Culver West

West Washington Blvd . Culver City . California 90066
Proposed Art and Color Revisions

may 2018

6-STORY MIXED-USE RETAIL & RESIDENTIAL BUILDING

louise ave (back)

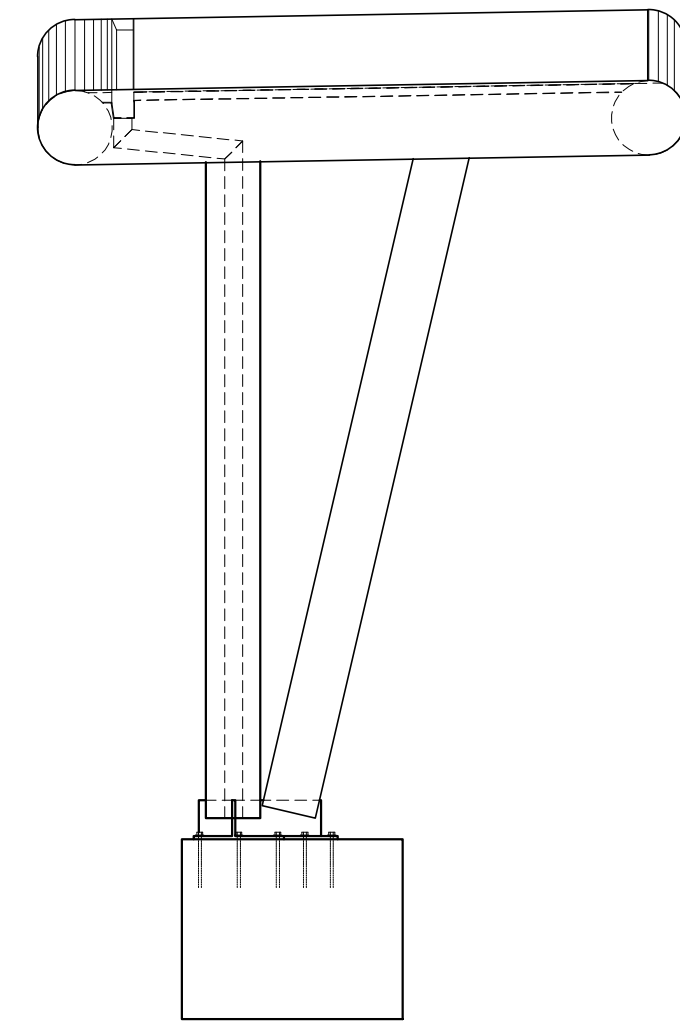
revised color

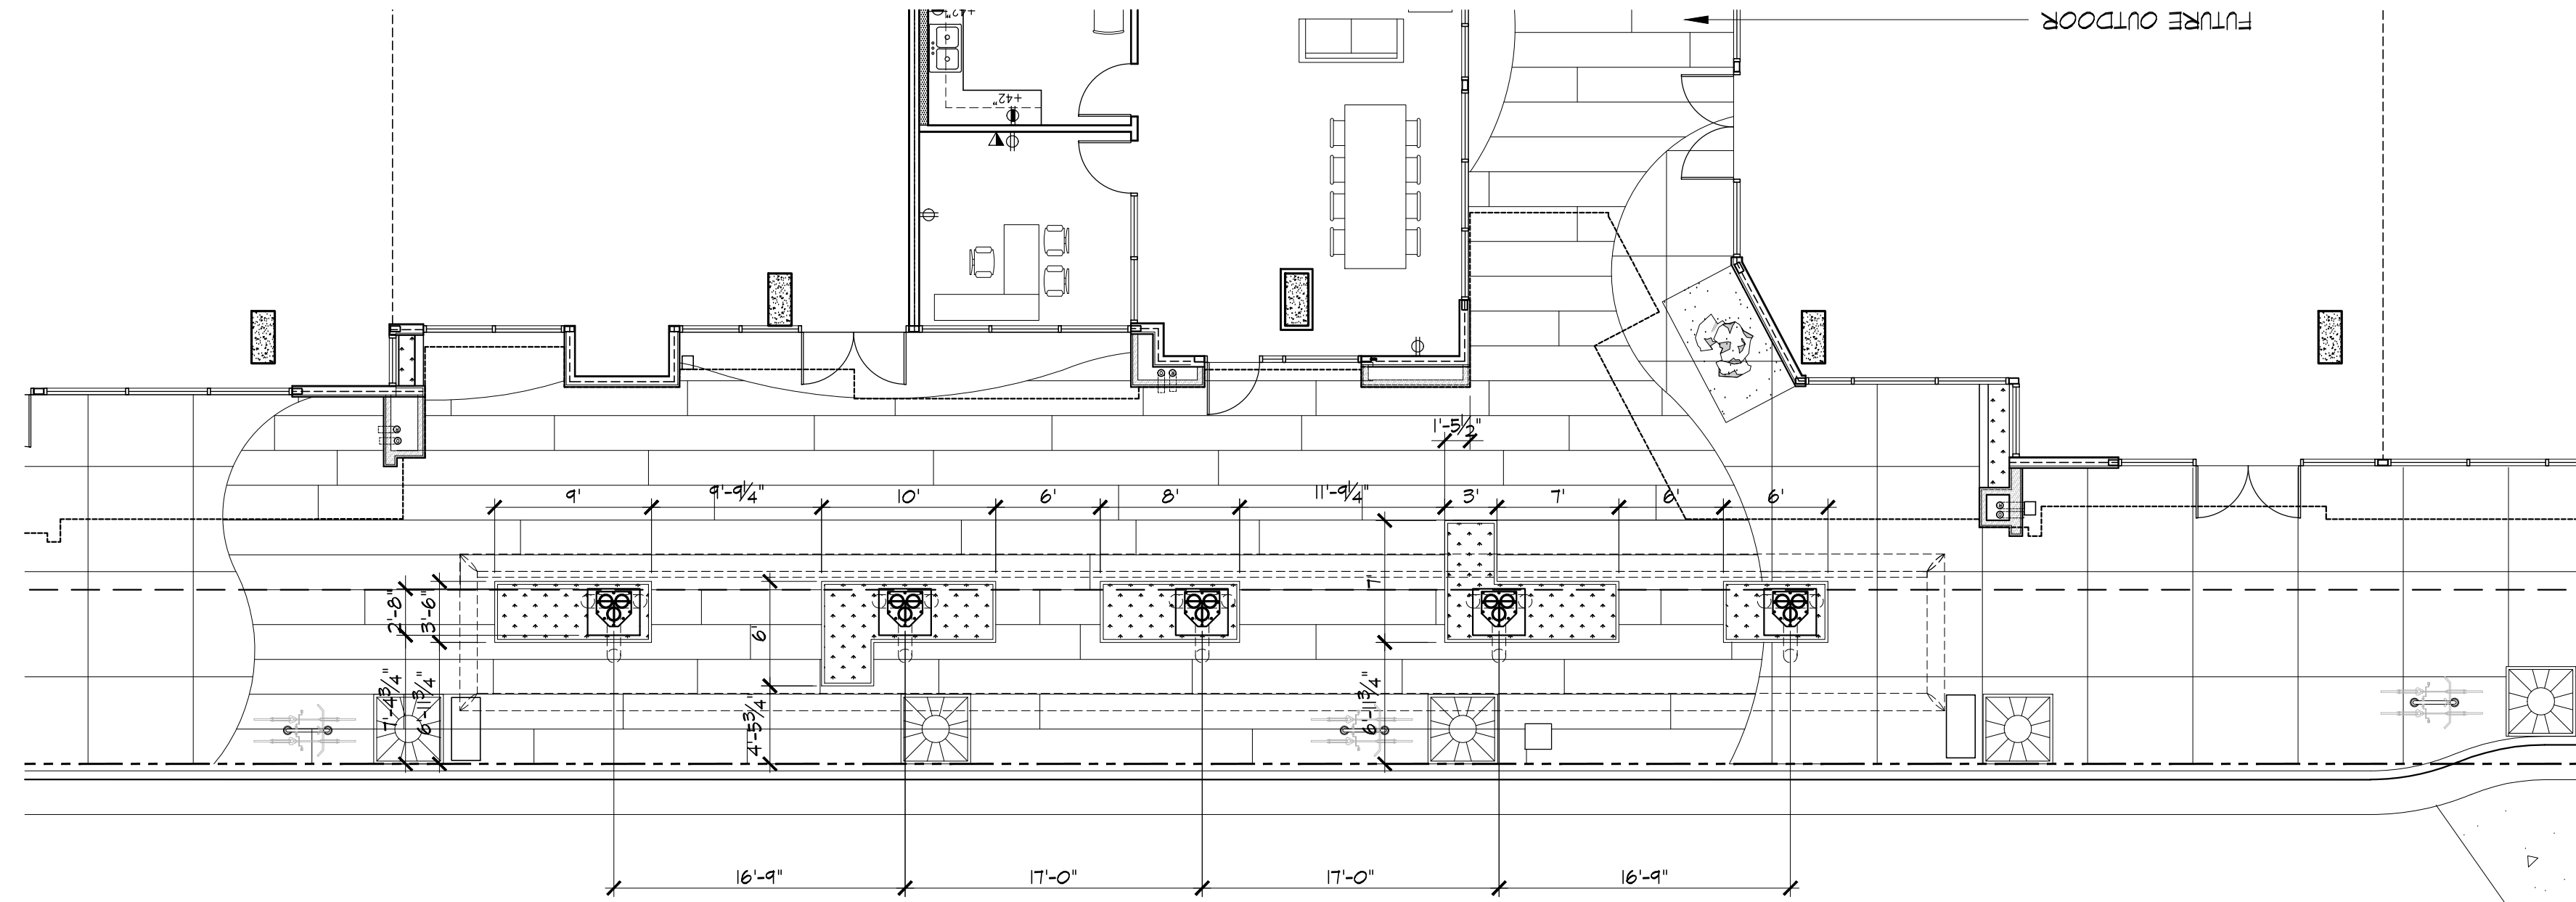
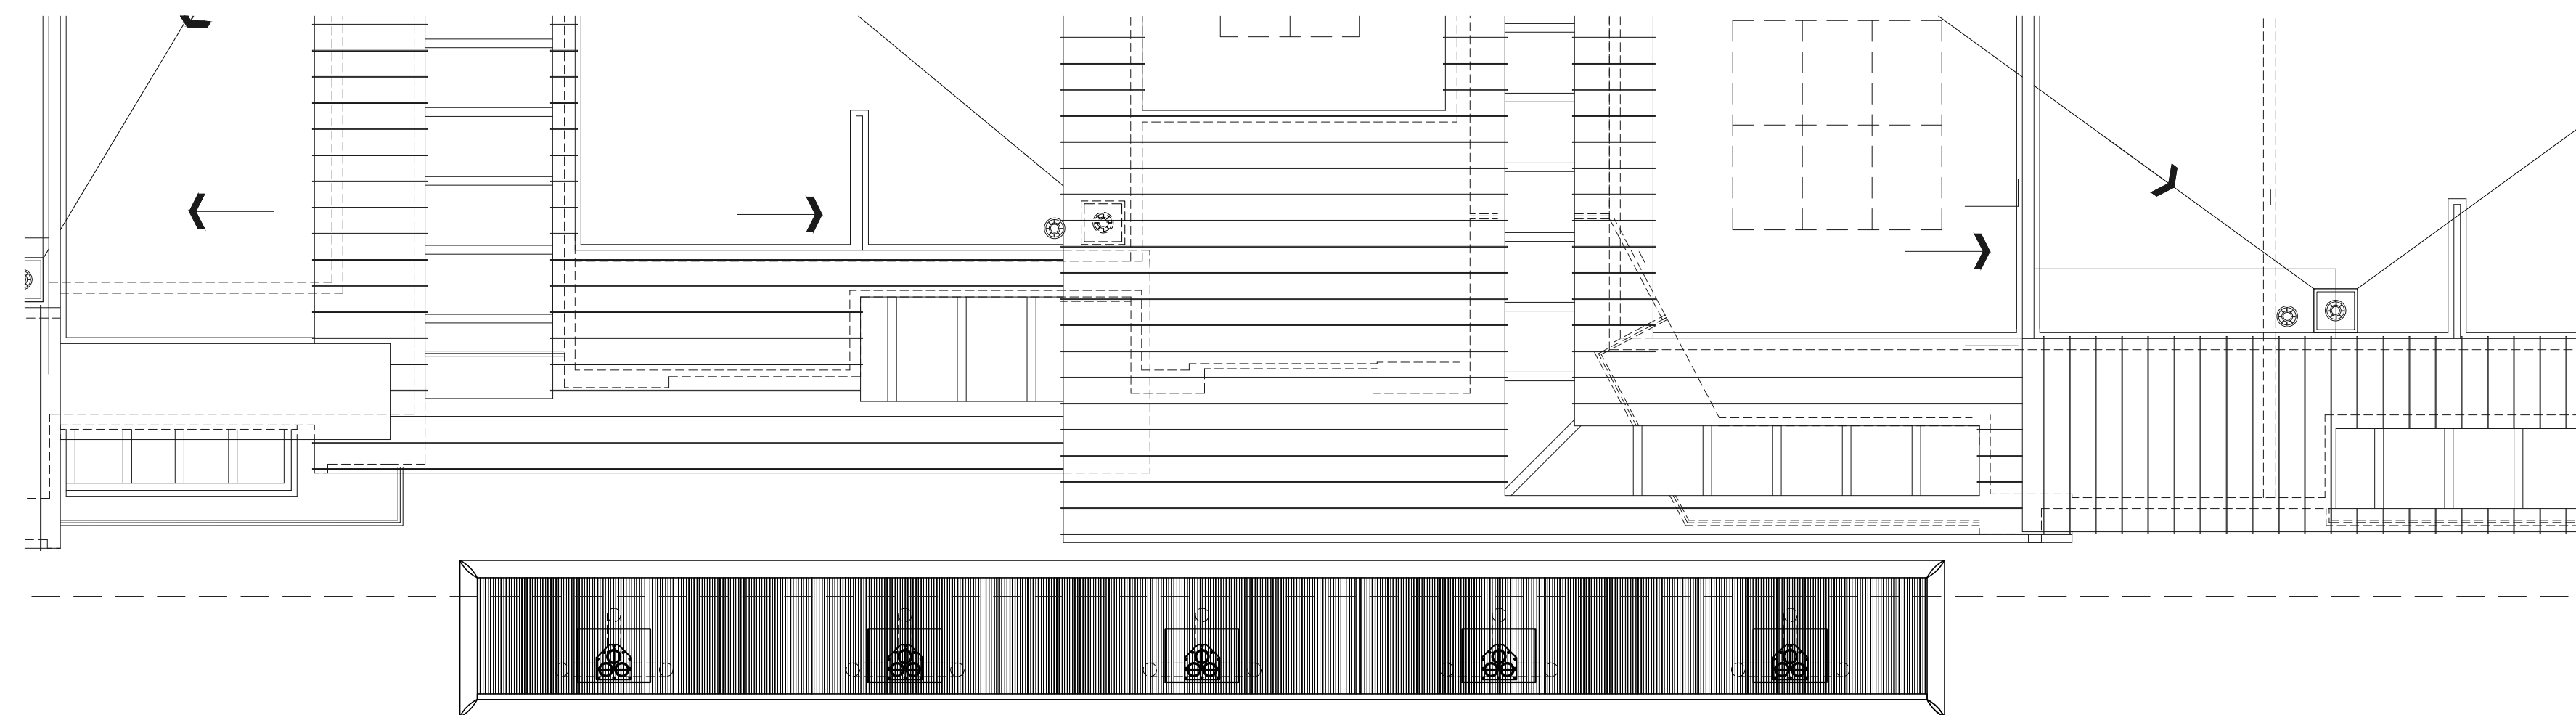
TRELLIS TO BE A DEFERRED SUBMITTAL
ENCROACHMENT PERMIT TO BE OBTAINED
FROM THE CITY PRIOR TO INSTALLATION.
TRELLIS WILL SATISFY THE PUBLIC ART
REQUIREMENT FROM THE CITY.

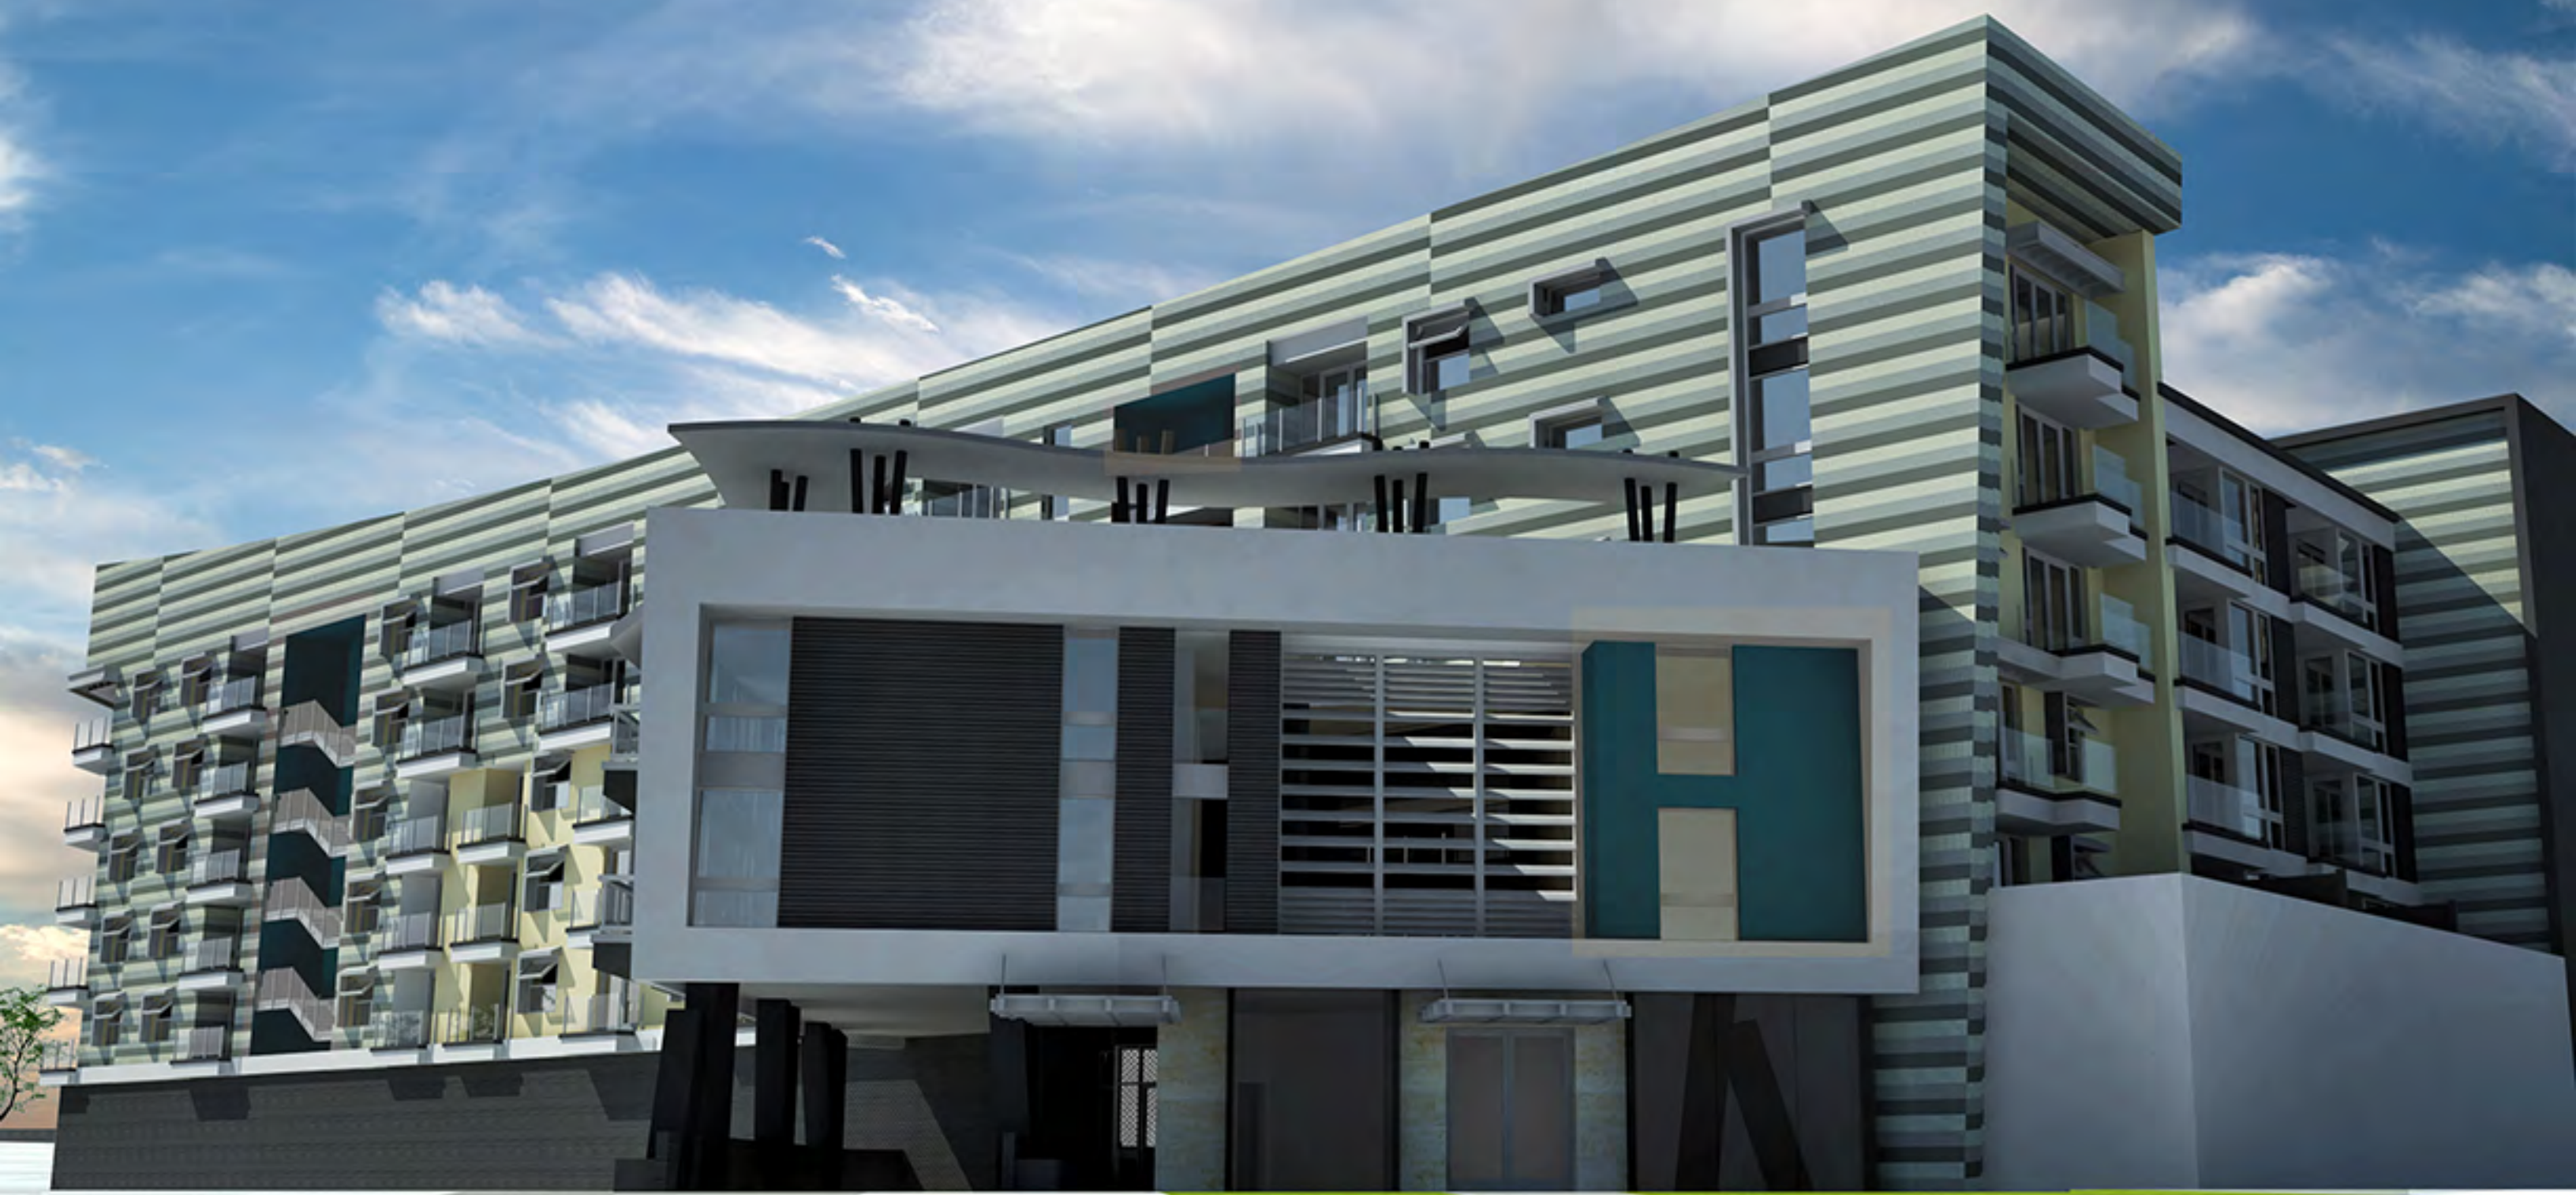
RE: Change of Cladding from Metal to Stucco at West Elevation
Culver West Building, Culver City California
